ENGINE – STAGE 1 TURBINE NOZZLE ASSEMBLY AND HP TURBINE ROTOR AND STATOR ASSEMBLY –  
INCORPORATION OF OFFSET SUPPORTS – CATEGORY CODE 6 – MOD.ENG-72-0002

- (1) Aircraft: Airbus A320
- (2) Engine: V2500-A1 Engines Serial No's. V0003 through V0028 except  
Engine Serial No. V0007

V2500-ENG-72-0002

Location of Stage 1 High Pressure Turbine Support Assembly  
Fig.1

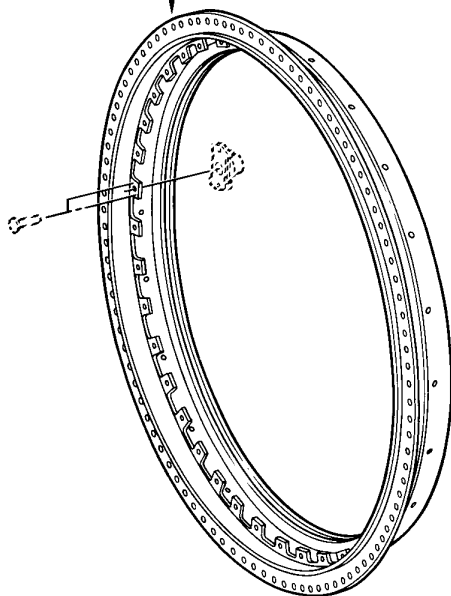
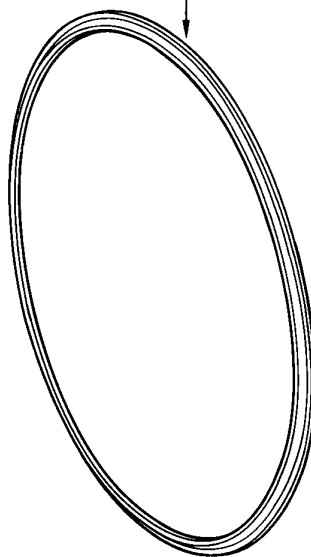
Procedure	Supplementary Information	
(a) Remove the 2A0170 Stage 1 HPT Seal (1 off).	Refer to Figure 1.	
(b) Set-up and machine to the dimensions given in C.	Refer to Figure 2.	
(c) Coat area D to 0.040-0.060 in. (1,02-1,52 mm). Use PWA 53-37.	Refer to Figure 2 for the location of the plasma coat. Coat will be applied by the procedure given in Reference (2), Chapter/Section 70-34-03, Plasma and Flame Spraying.	
NOTE: If not removed the nut plates will be masked when the plasma coat is applied.		
(d) Set-up and machine to the dimensions given in F.	Refer to Figure 2.	
(e) Install the 2A0170 Stage 1 HPT Seal (1 off).	Refer to Figure 1.	
(f) Mark the new part number adjacent to the existing part number. Use the vibration peen method.	Existing	New Part Number
	2A1292	2A1358
	2A1293	2A1359
	Refer to Figure 2. Refer to Reference (2), Control No./Task No. 70-09-00-400-501.

Location of Stage 2 High Pressure Turbine Support Assembly  
Fig.3

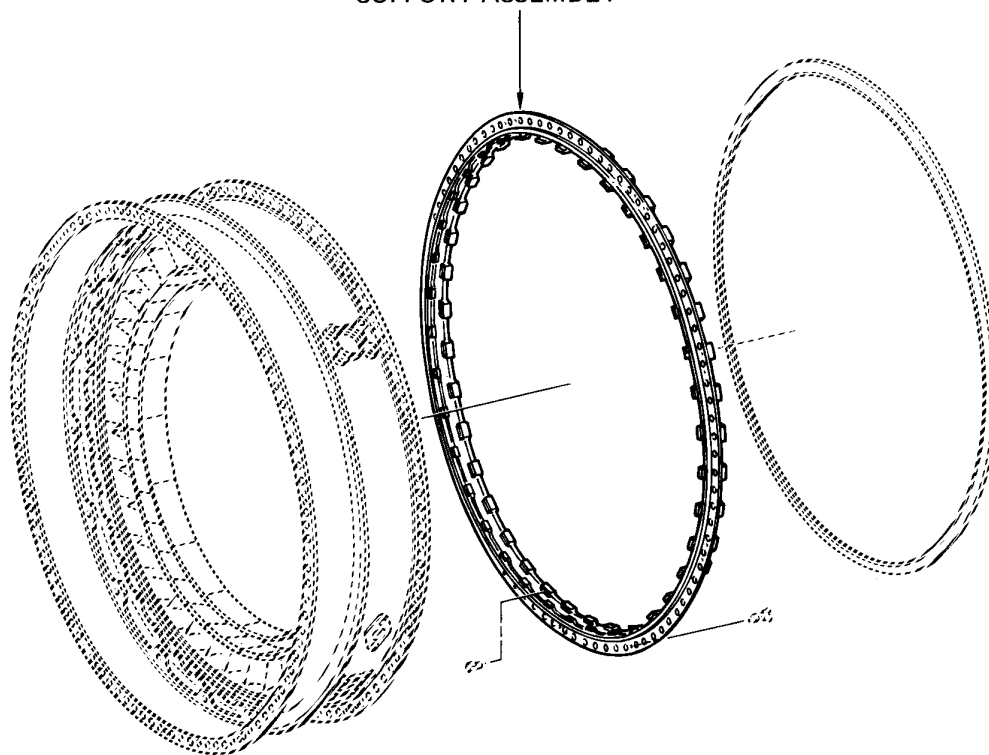
Procedure	Supplementary Information
(a) Set-up and machine to the dimensions given in E.	Refer to Figure 3 and Figure 4 (Sheets 1 and 2).

Modification of Stage 2 High Pressure Turbine Support Assembly  
Fig.4 (Sheet 1 of 2)

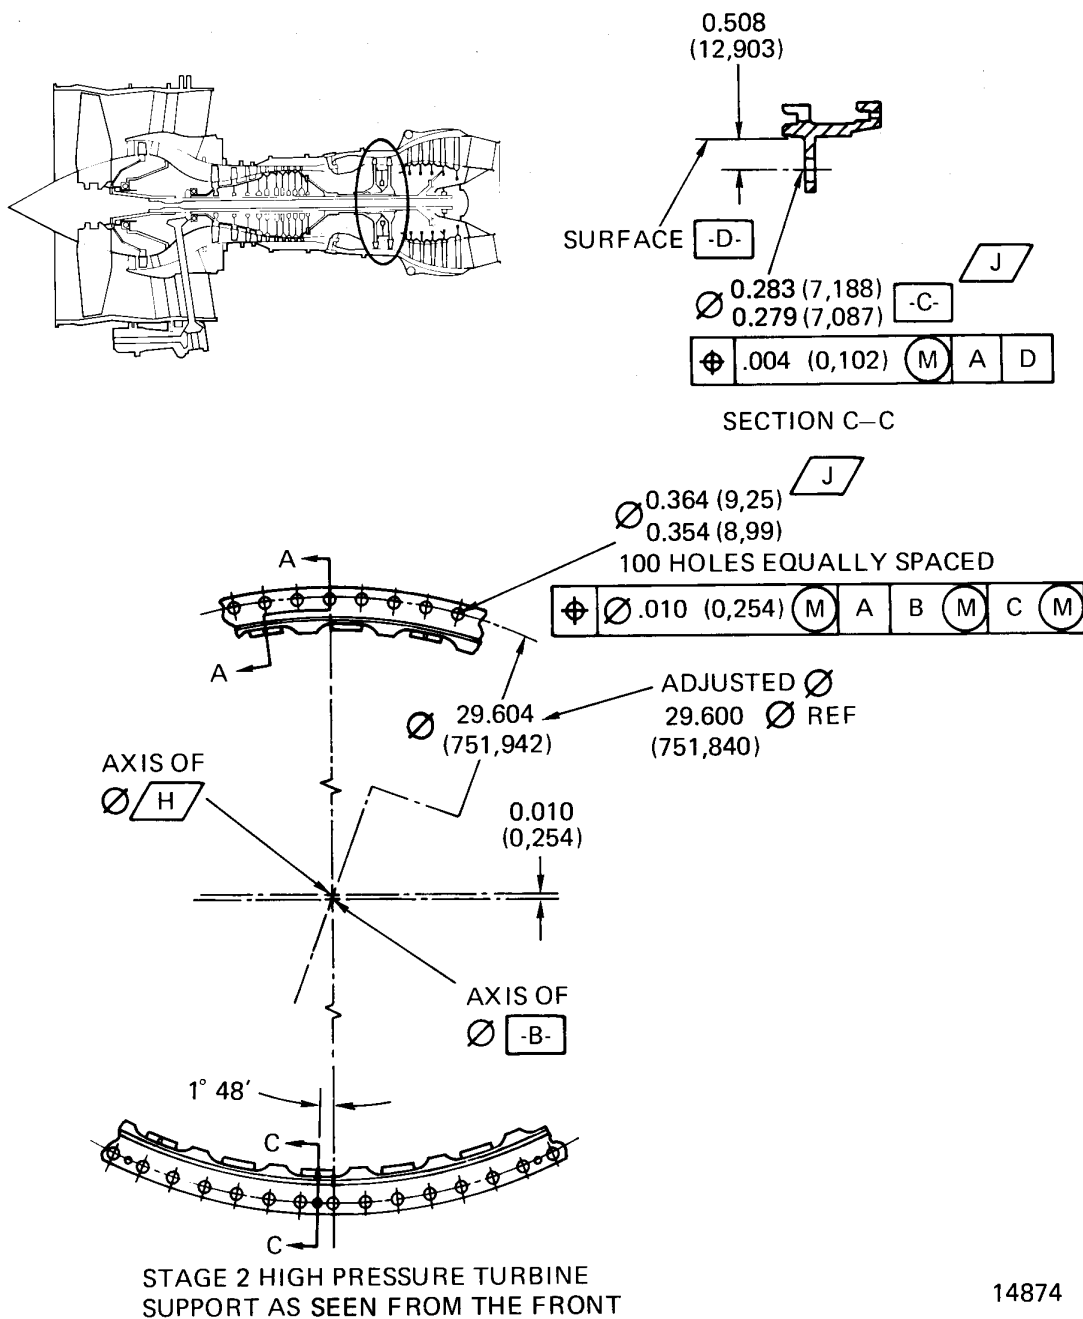
- (e) Set-up and machine holes J to the dimensions given.

Refer to Figure 4 (sheet 1).

Modification of Stage 2 High Pressure Turbine Support Assembly  
Fig.4 (Sheet 2 of 2)

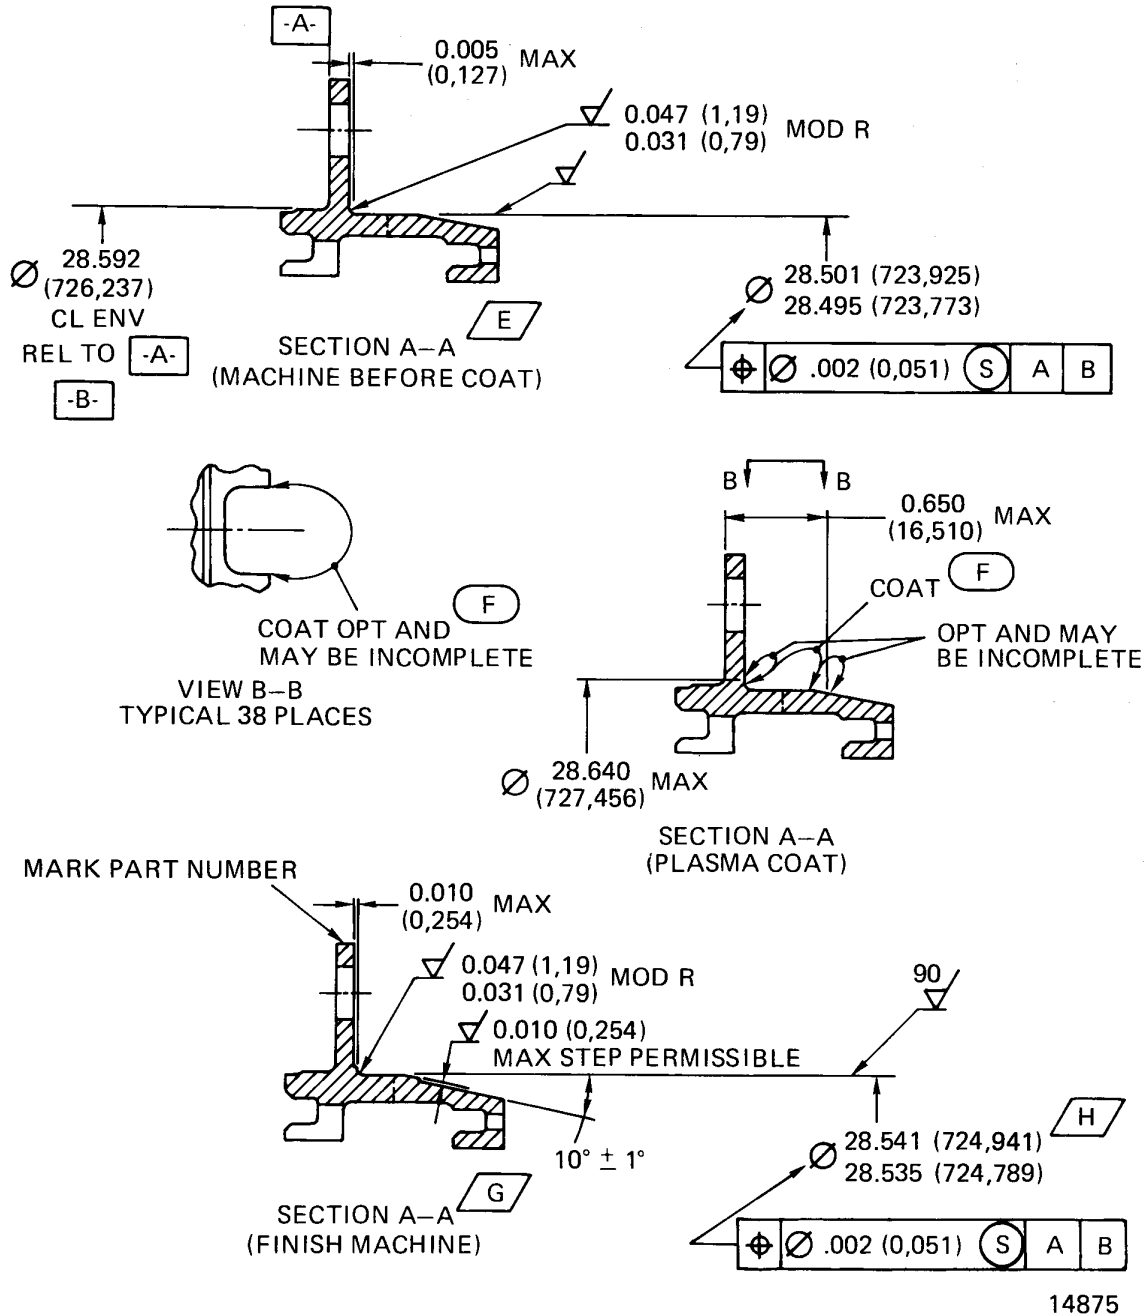
- (b) Coat area F to 0.040-0.060 in.  
(1,02-1,52 mm). Use PWA 53-37.

Refer to Figure 4 (Sheet 2) for the location of the plasma coat. Coat will be applied by the procedure given in Reference (2), Chapter/Section 70-34-03, Plasma and Flame Spraying.

- (c) Finish machine the support to the dimensions given in G.

- (f) Mark the new part number adjacent to the existing part number. Use the vibration peen method.

Refer to Figure 4 (Sheet 2).  
Refer to Reference (2), Control No./Task No. 70-09-00-400-501.

Modification of Turbine Case Assembly  
Fig.5 (Sheet 1 of 3)

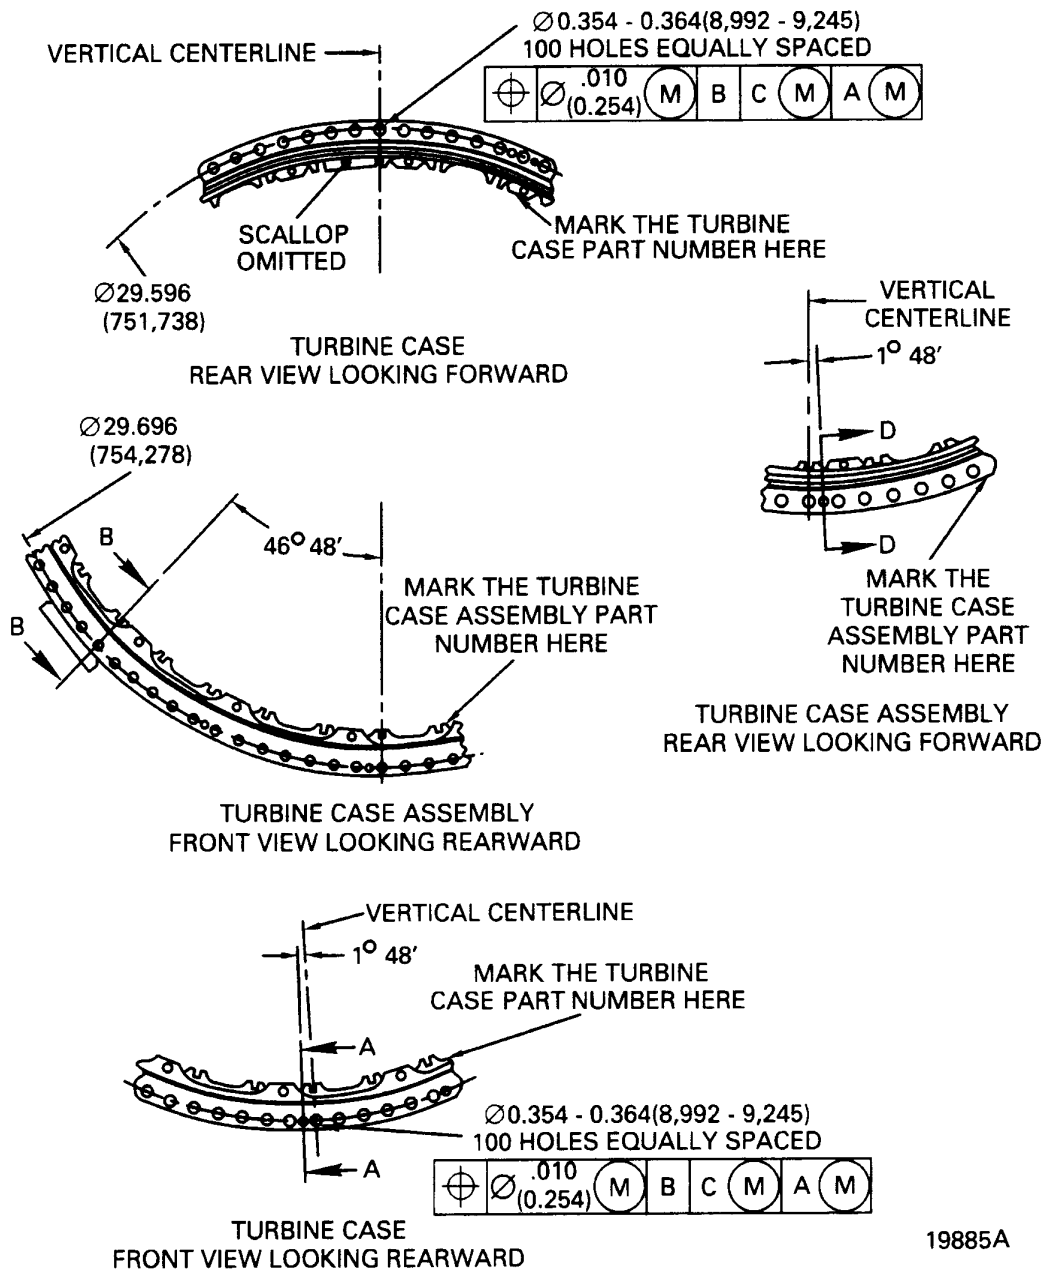
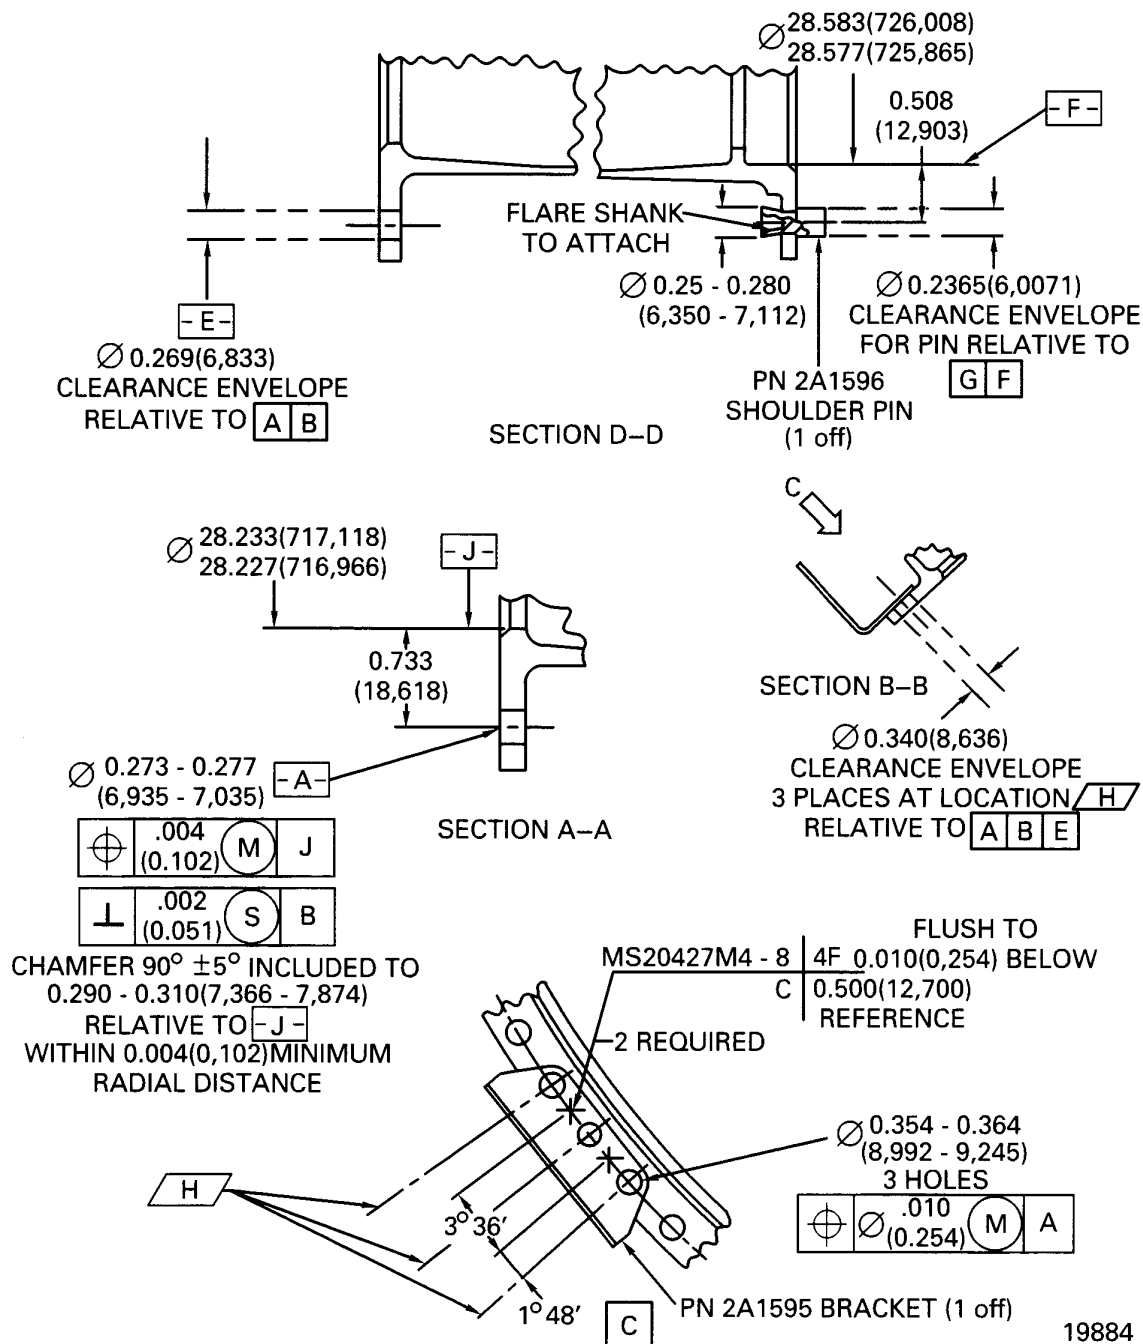
- (a) Set-up and machine the flange bolt holes on the front flange of the Turbine Case.

- (b) Set-up and machine the flange bolt holes on the rear flange of the Turbine Case.

- (c) Set-up and machine the location pin hole in the front flange of the Turbine Case.

- (d) Mark the new part number adjacent to the existing part number. Use the vibration peen method.

Procedure	Supplementary Information	
(a) Rivet the Turbine Case Bracket to the Turbine Case by the procedure specified.	Refer to Figure 5, requirements. Refer to Reference (2), Control No./Task No. 70-39-00-390-501.	
(b) Transfer drill through the holes in the Turbine Case to enlarge three holes in the Turbine Case Bracket.	Refer to Figure 5, requirements.	
(c) Mark the new part number adjacent to the existing part number. Use the vibration peen method.	Existing	New Part Number
	2A0286	2A1595
	Refer to Figure 5, requirements. Refer to Reference (2), Control No./Task No. 70-09-00-400-501.

Procedure	Supplementary Information	
(a) Install the 2A1596 Shoulder Pin (1 off) in the rear flange of the Turbine Case by the procedure specified.	Refer to Figure 5, requirements.	
(c) Mark the new part number adjacent to the existing part number. Use the vibration peen method.	Existing	New Part Number
	2A0250	2A1600
	Refer to Figure 5, requirements. Refer to Reference (2), Control No./Task No. 70-09-00-400-501.

DO A MODIFICATION TO THE  
2A0200 TURBINE CASE  
IDENTIFY AND INSTALL AS  
2A1599 TURBINE CASE (1 off)

DO A MODIFICATION  
TO THE 2A0286  
TURBINE CASE BRACKET  
IDENTIFY AND INSTALL  
AS 2A1595 TURBINE  
CASE BRACKET (1 off)

INSTALL THE  
2A1596 PIN  
(1 off)

ASSEMBLE THE MODIFIED TURBINE CASE  
AND TURBINE CASE BRACKET  
IDENTIFY AS 2A1600 TURBINE  
CASE ASSEMBLY (1 off)
